This amendment revises the pressure-temperature operating limits for the D. C. Cook Unit No. 1 pressure vessel.

DONALD C. COOK NUCLEAR PLANT UNIT NO. 1

Amendment No. 41  
License No. DPR-58

SAFETY EVALUATION BY THE OFFICE OF NUCLEAR REACTOR REGULATION  
RELATED TO AMENDMENT NO. 41 TO FACILITY OPERATING LICENSE NO. DPR-58  
INDIANA AND MICHIGAN ELECTRIC COMPANY  
DONALD C. COOK NUCLEAR PLANT UNIT NO. 1  
DOCKET NO. 50-315

FIGURE 3.4-2

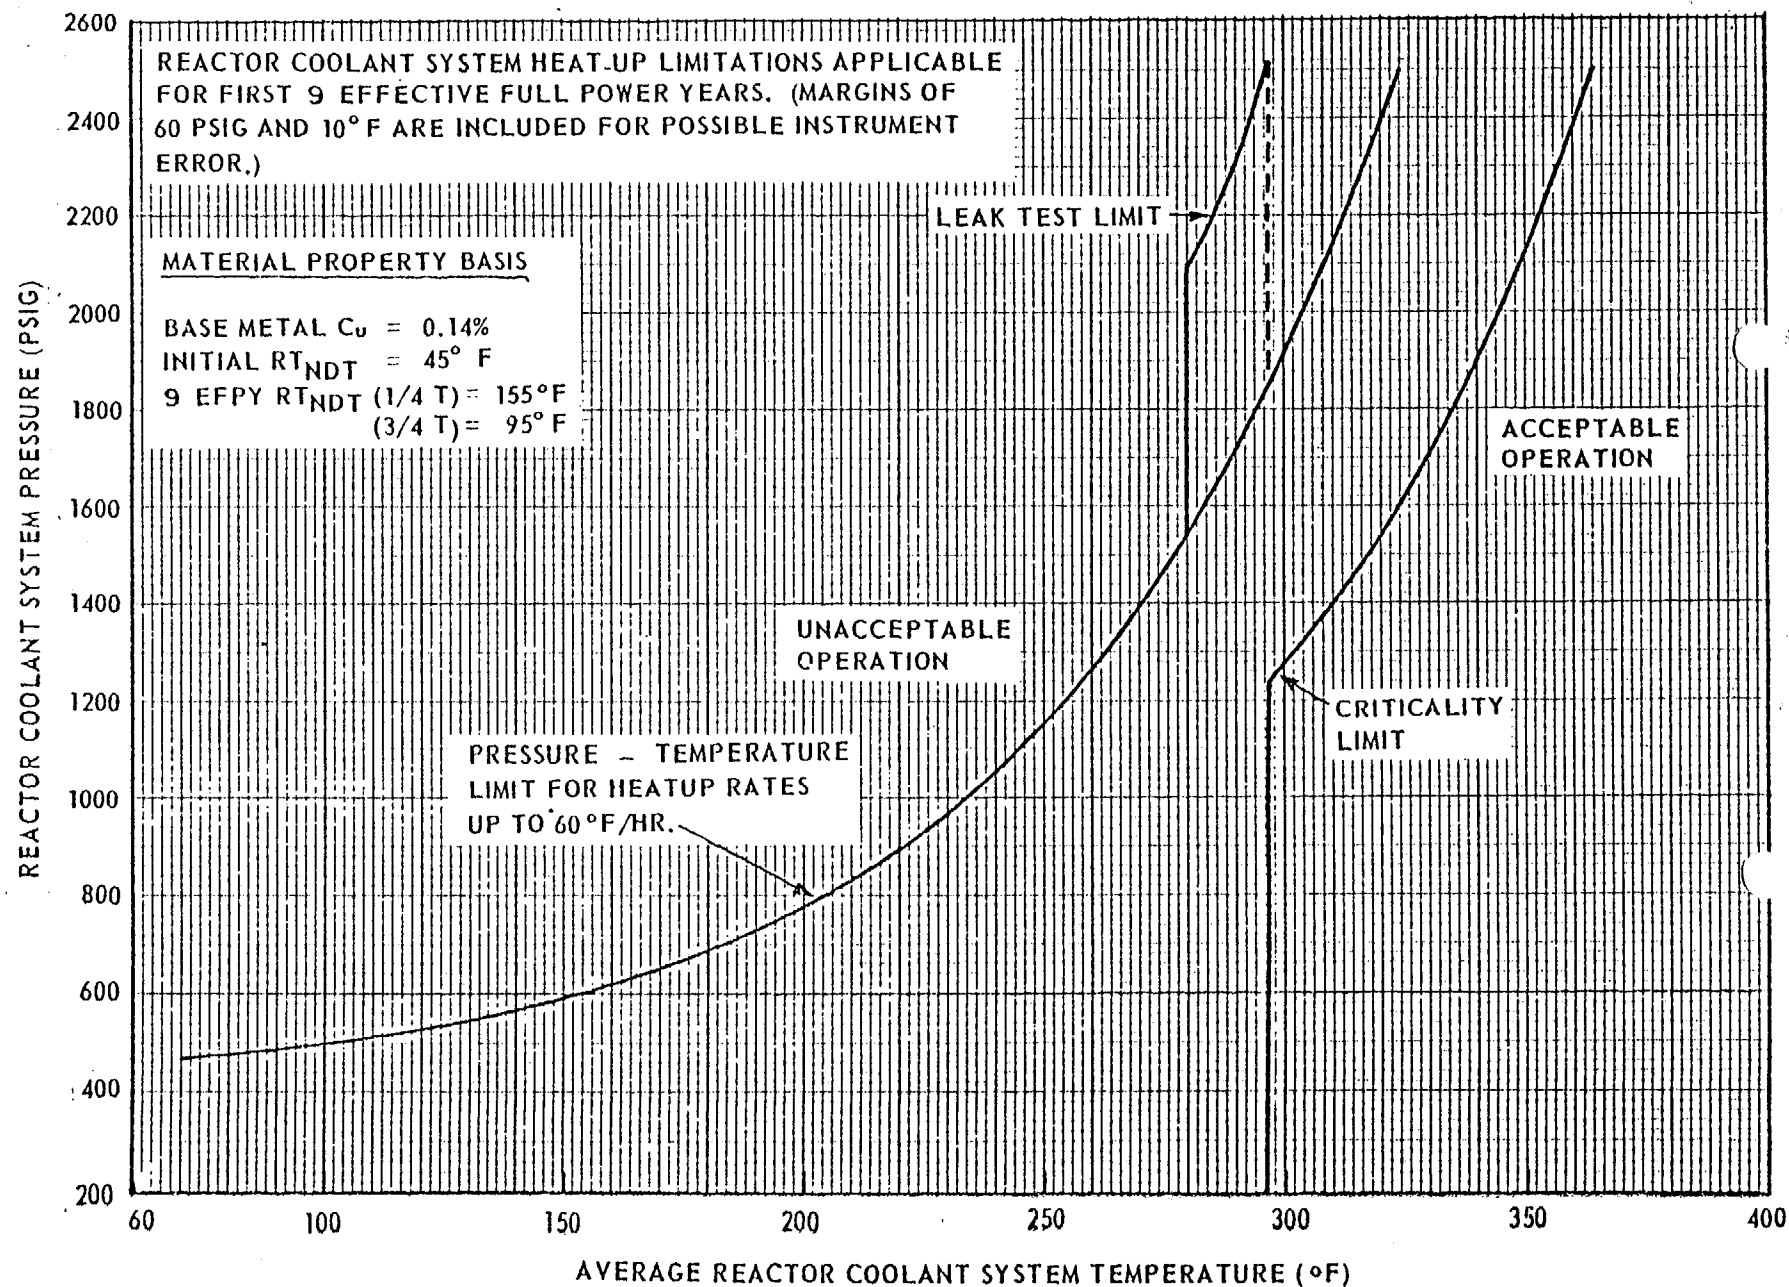
By letter dated February 22, 1980, Indiana and Michigan Electric Company requested a change to the Technical Specifications of Cook 1 regarding the pressure-temperature operating limits for the reactor vessel. The proposed operating limits are applicable for 12 EFPY and are based on the test results from material surveillance capsule T. The fluence on this capsule is  $1.8 \times 10^{18}$  m/cm<sup>2</sup>. This fluence caused the  $RT_{NDT}$  of plate

material to increase by 75°F and the RTNDT of weld material to increase by 130°F. The initial, or unirradiated RTNDT of the limiting plate and weld materials were assumed to be 55 and -70°F.

We have performed independent calculations to verify the validity of the proposed limits. We conclude that the limiting material is weld metal in the intermediate to lower shell circumferential seam. In accordance with Indiana and Michigan Power Company letter dated November 7, 1977, the initial RTNDT of this material is 0°F. The proposed operating limits are calculated for a radiated value of RTNDT of 155°F. Our calculations show that the limiting weld metal will reach this value at 9 EFPY. Our calculations agree with the remainder of the calculations submitted. Therefore, the proposed operating limits are acceptable for operation through 9 EFPY and are in accordance with Appendix G, 10 CFR 50 for this operating period. Conformance with Appendix G to 10 CFR Part 50 in establishing safe operating limitations will ensure adequate safety margins during operation, testing, maintenance and postulated accident conditions and constitutes an acceptable basis for satisfying the requirements to NRC General Design Criterion 31, Appendix A, 10 CFR Part 50.
